DETAILED ACTION**Election/Restrictions**

Art Unit: 2832

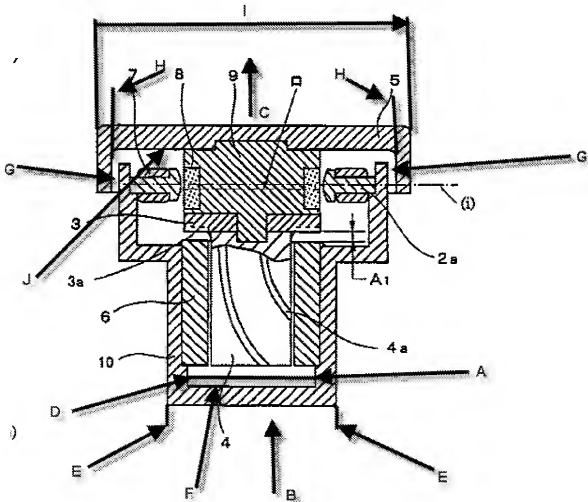
20. Regarding **claim 14**, at [figs. 2a/2b and the annotated drawing in page 11] Komura teaches a first can [10] comprising a first continuous can member [10] comprising a first sidewall [A] circularly symmetric about and extending along a first axis [B], having an inner first diameter [D] and an outer second diameter [E] differing there between by twice a first wall thickness, and a first end [F] extending transversely to the first axis [B], having a first end thickness, and connected to the first sidewall [A]; and a second can [5] comprising a second continuous can member [5] comprising a second sidewall [G] circularly symmetric about and extending along a second axis [C] disposable along the first axis [B], having an inner third diameter [H/H] and an outer fourth diameter [I] differing there between by twice a second wall thickness, a second end [J] extending transversely to the second axis [C] and connected to the second sidewall [G], and a third sidewall [J] circularly symmetric about and extending along the second axis [C], having an inner diameter [H/H] larger than the second diameter [E] by a first clearance [HE] and an outer sixth diameter [I] greater than the fifth diameter [H/H] by twice a third wall thickness, and connected to the second sidewall [G] on a side thereof opposite the second end [J]; whereby the third sidewall is slidable over a radial outside of the first sidewall [fig. 2a] so that
